ARKANSAS NUCLEAR ONE, UNIT 1

AMENDMENT TO FACILITY OPERATING LICENSE

Amendment No. 83  
License No. DPR-51

SAFETY EVALUATION BY THE OFFICE OF NUCLEAR REACTOR REGULATION  
SUPPORTING AMENDMENT NO. 83 TO FACILITY OPERATING LICENSE NO. DPR-51

Figure 3.1.2-1

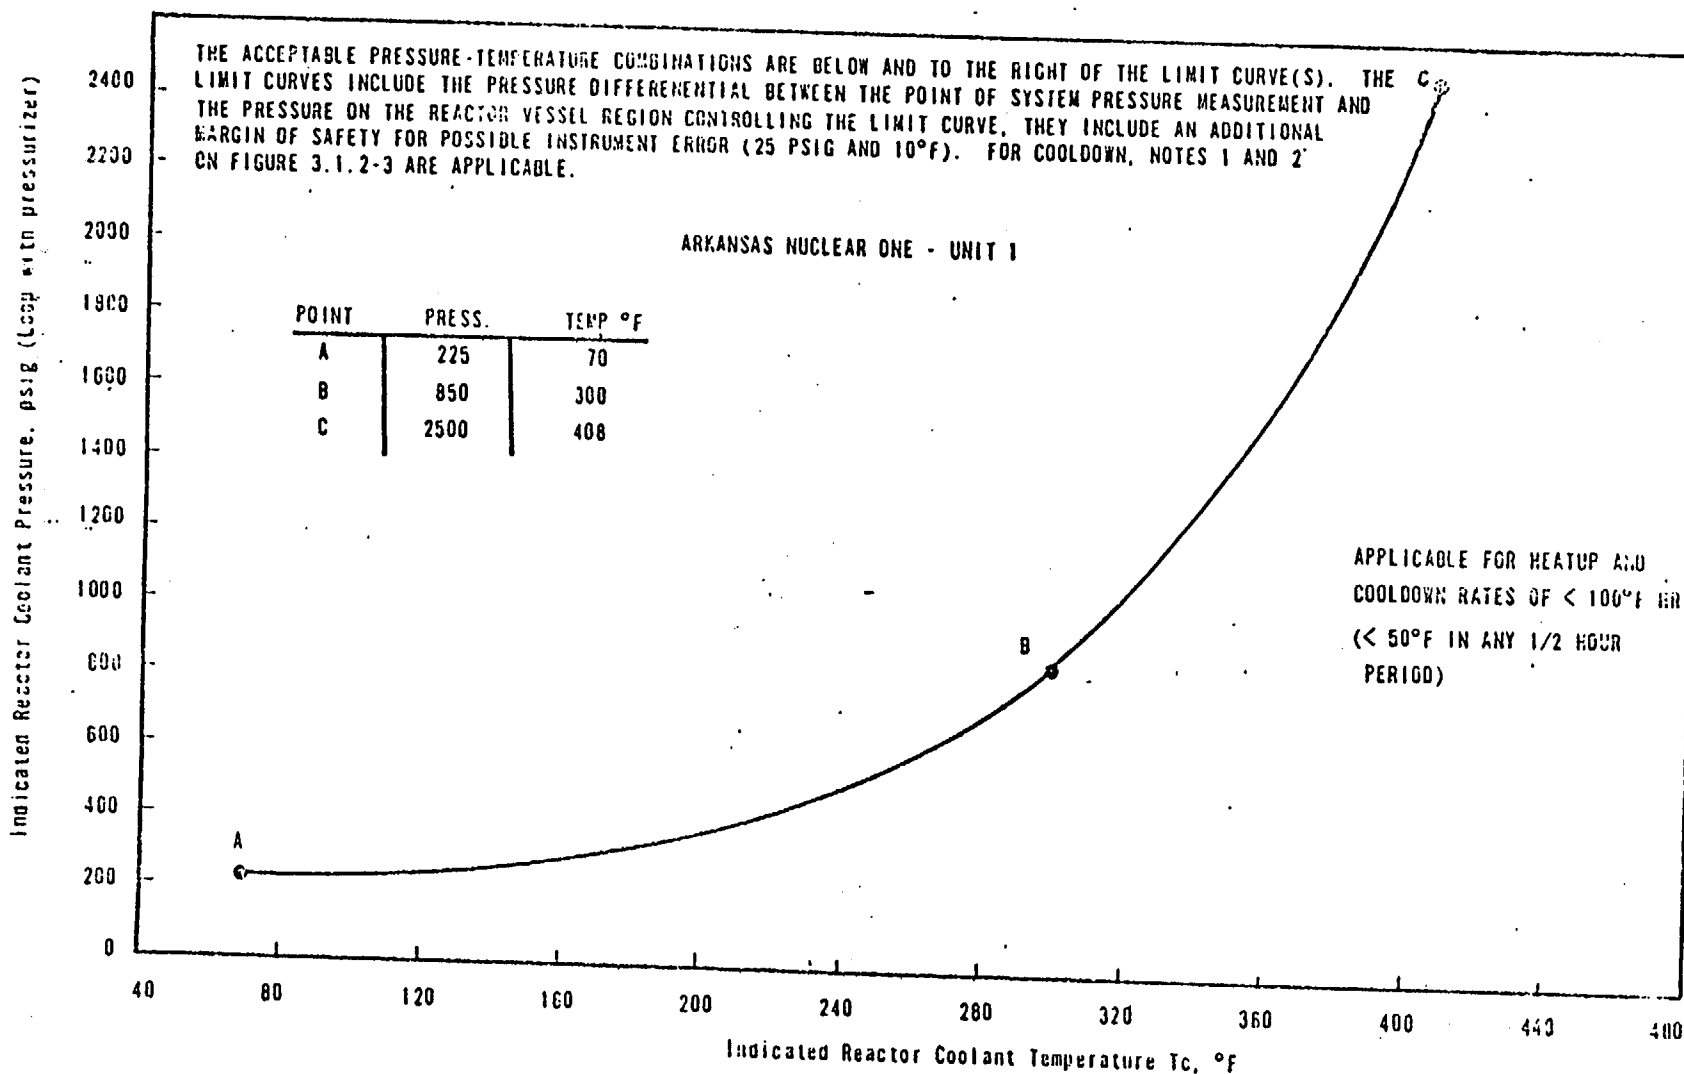
The amendment modifies the ANO-1 TS pressure-temperature limit curves for hydrostatic test, normal heatup and normal cooldown. Also, the amendment requires that these pressure-temperature curves be updated prior to reaching 15 effective full power years of operation.

Figures 3.1.2-1, 3.1.2-2, and 3.1.2-3 present the pressure-temperature limit curves for hydrostatic test, normal heatup, and normal cooldown respectively. The limit curves are applicable through the fifteenth effective full power year of operation. These curves are adjusted by 25 psi and 10F for possible errors in the pressure and temperature sensing instruments. The pressure limit is also adjusted for the pressure differential between the point of system pressure measurement and the limiting component for all operating reactor coolant pump combinations.

The pressure-temperature limit lines shown on Figure 3.1.2-2 for reactor criticality and on Figure 3.1.2-1 for hydrostatic testing have been provided to assure compliance with the minimum temperature requirements of Appendix G to 10CFR50 for reactor criticality and for inservice hydrostatic testing.

- 3.1.2.7 Prior to reaching fifteen effective full power years of operation, Figures 3.1.2-1, 3.1.2-2 and 3.1.2-3 shall be updated for the next service period in accordance with 10CFR50, Appendix G, Section V.B. The service period shall be of sufficient duration to permit the scheduled evaluation of a portion of the surveillance data scheduled in accordance with Specification 4.2.7. The highest predicted adjusted reference temperature of all the beltline region materials shall be used to determine the adjusted reference temperature at the end of the service period. The basis for this prediction shall be submitted for NRC staff review in accordance with Specification 3.1.2.8. The provisions of Specifications 3.0.3 and 3.0.4 are not applicable.
